Ocean velocity observations are presently not routinely assimilated in most ocean forecasting systems. This is largely due to the availability of NRT surface velocity observations which provided sufficient spatial coverage. This study looks at the impact of assimilating a novel surface velocity product into a multi model ensemble. Ocean surface velocities are derived from AVHRR SSTs using a maximum cross-correlation algorithm. The authors describe the methods used to process the data and outline the multi-model Ensemble Kalman filter used to assimilate the observations. I believe that this study is of interest to the community as it expands on the relatively limited field of ocean velocity assimilation. However, I feel the paper would benefit from significant revisions. In many places the explanations are unclear and in some places, there are contradictions in the text. In addition, many of the results need a clearer benchmark to allow meaningful conclusions to be drawn.

Main general comments:

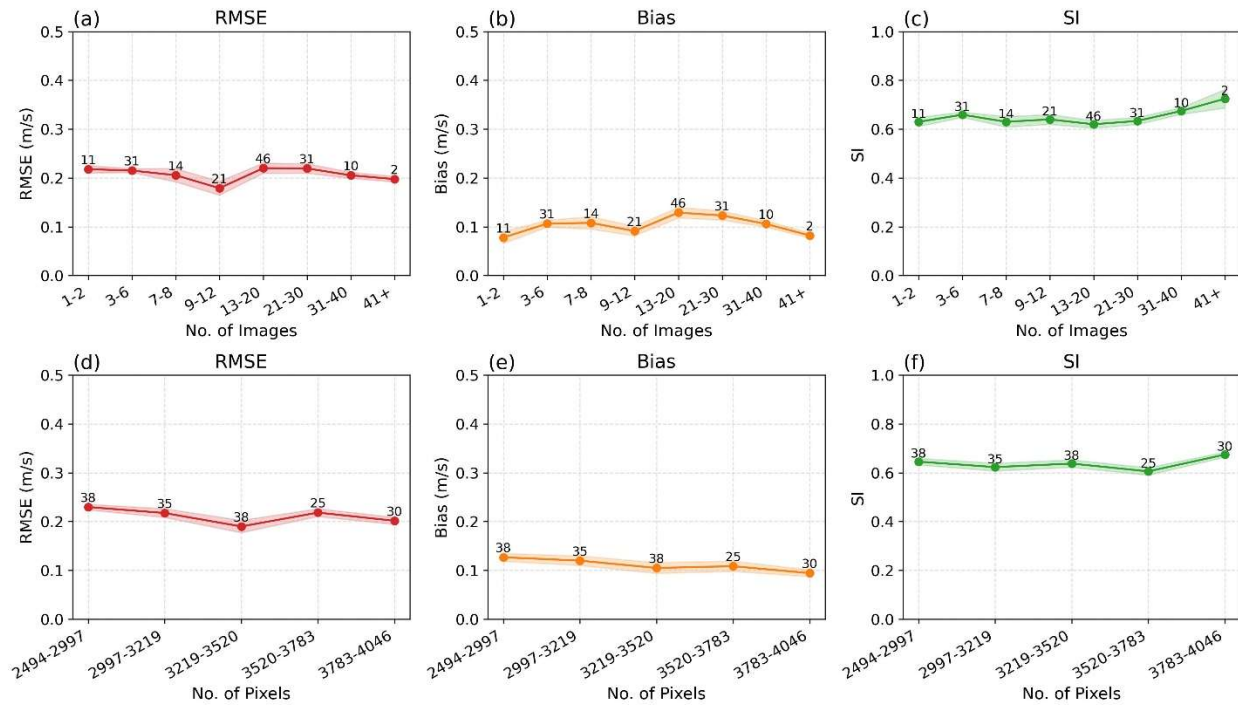
49. Section 4.3.1 – In figure 17 and 18 how much are the results impacted by the number of samples in each bin? The results may not very robust if there are only a small number of samples in some of the bin. This should be taken into account when the authors draw their conclusions from the data.

We thank the reviewer for highlighting the importance of sample size when interpreting the binned sensitivity analyses. To address this concern, Figures 17 and 18 have been substantially revised. Figure 17 now reports the number of assimilation cycles contributing to each bin together with the corresponding ± 1 standard error envelopes, allowing the statistical robustness of each estimate to be assessed directly. Figure 18 has also been redesigned to include a sample-count-weighted representation of the joint RMSE distribution, distinguishing systematic performance patterns from isolated low-error bins supported by only a few samples. The revised figures are included with the response.

The accompanying discussion has also been updated accordingly. Rather than emphasizing isolated minima, the revised interpretation now focuses on the observational regimes that are consistently supported by sufficient numbers of assimilation cycles. The analysis shows that the most robust assimilation performance occurs for intermediate observational densities (approximately 9–20 assimilated EO products) combined with moderate-to-high spatial coverage (approximately 3000–3500 valid observation pixels), where both the error metrics and the sample populations are favorable. Conversely, several bins exhibiting very low RMSE are now explicitly identified as being supported by only one or two assimilation cycles and are therefore not interpreted as statistically robust. Similarly, the apparent increase in SI at the highest observational densities is no longer interpreted as a meaningful trend because it is based on only two samples. These revisions ensure that the conclusions are supported by the statistical confidence associated with each observational regime rather than by isolated low-error cases.

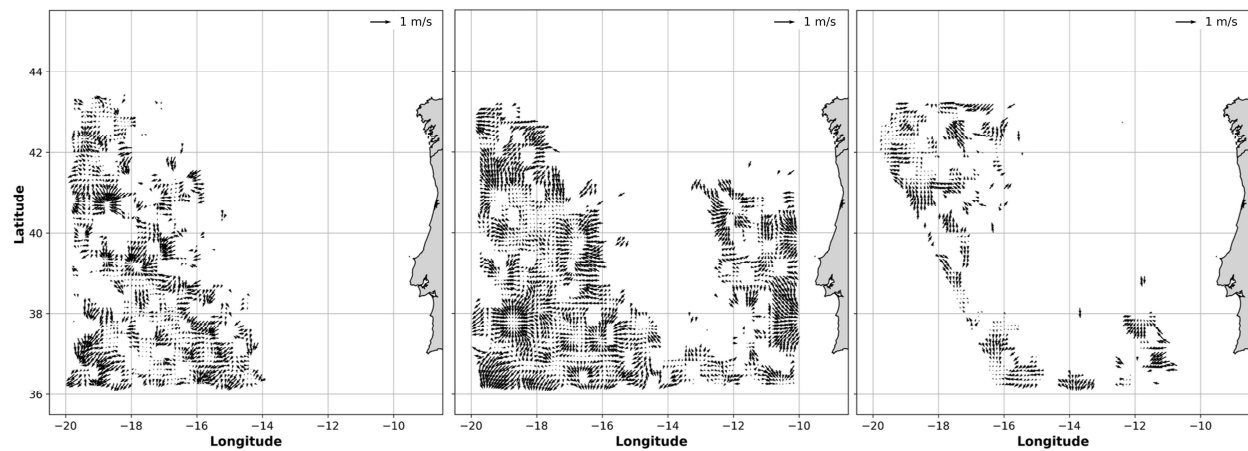
3. The paper would benefit from providing an example MCC EO image

Response: A representative example of the MCC-derived EO surface current field has been added to the revised manuscript (new Figure 3 in Section 3.1). This figure provides a visual example of the MCC-derived observations used in the data assimilation framework and improves the description of the EO retrieval process.
